## LYCEUM THEATRE - PUBLIC SPACES RENOVATION

BID NO.:	K-15-6426-DBB-3	
SAP NO. (WBS/IO/CC):	24005563	
CLIENT DEPARTMENT:	1611	<u> </u>
COUNCIL DISTRICT:	3	
PROJECT TYPE:	BT

ADDENDUM "B"

2. To Attachment E, Supplementary Special Provisions, Appendices, Appendix A, Lyceum Phasing Report, pages 867 through 869, **DELETE** in their entirety and **SUBSTITUTE** with pages 5 through 7 of this Addendum.

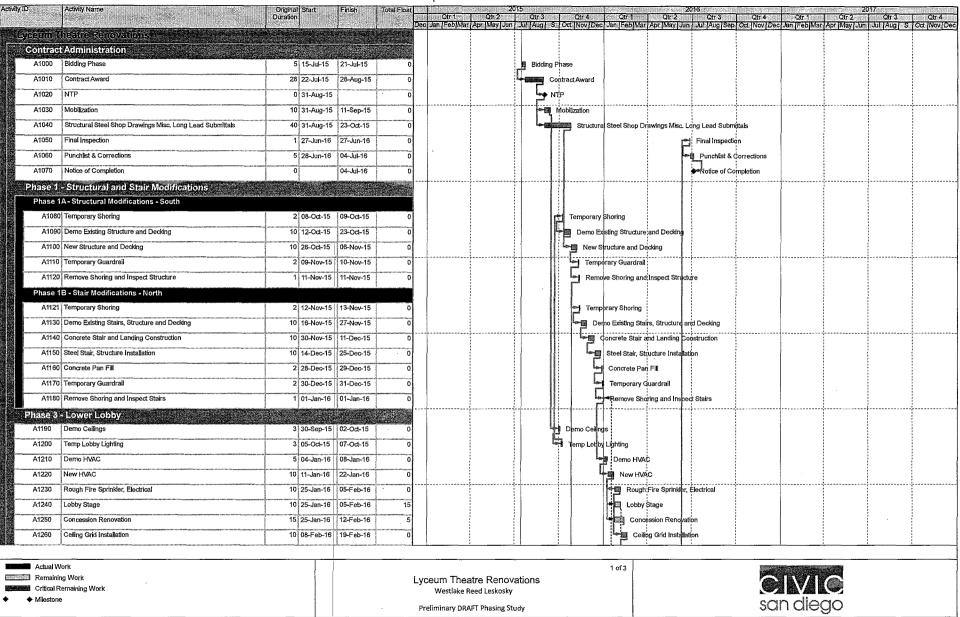
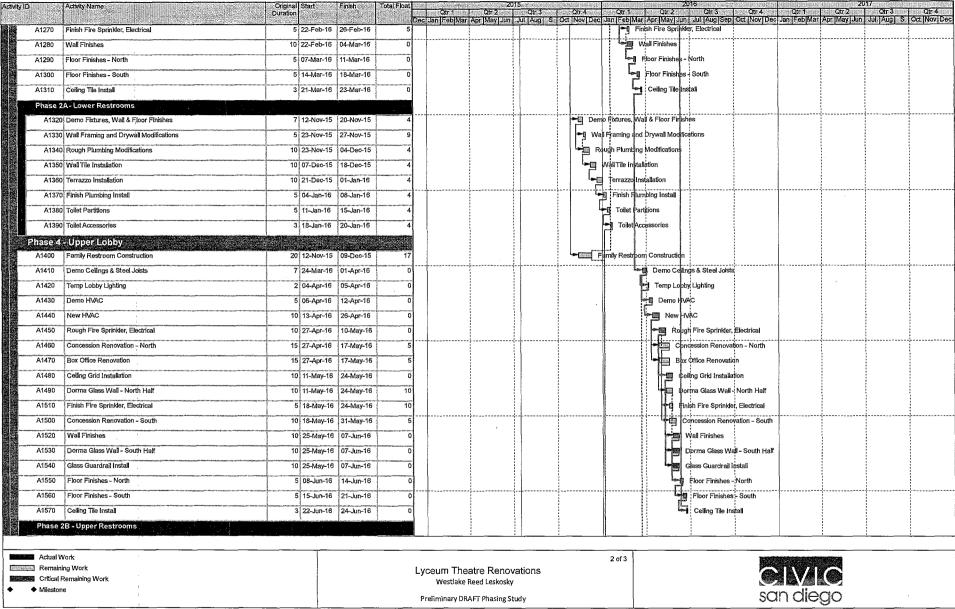
- Q5. Per Appendix A Lyceum Phasing Report. The Phasing report and schedule has dates going back to 2011. Will this Phasing Plan and Schedule be updated before bid day? Please advise?
- A5. The Schedule has been updated and is attached
- Q6. Please verify speaker quantities. Equipment list in the spec section calls for a total of 29 while the floor plans on sheets TA-121 and TA-122 show a total of 48 (12 with existing back cans).
- A6. The most recent issue of the floor plans and reflected ceiling plans show a total of 49 ceiling loudspeakers, (29) in the Lobby and (20) in the backstage and support spaces. Of the (20) located in the backstage areas, (12) of those are replacing units in existing back cans.
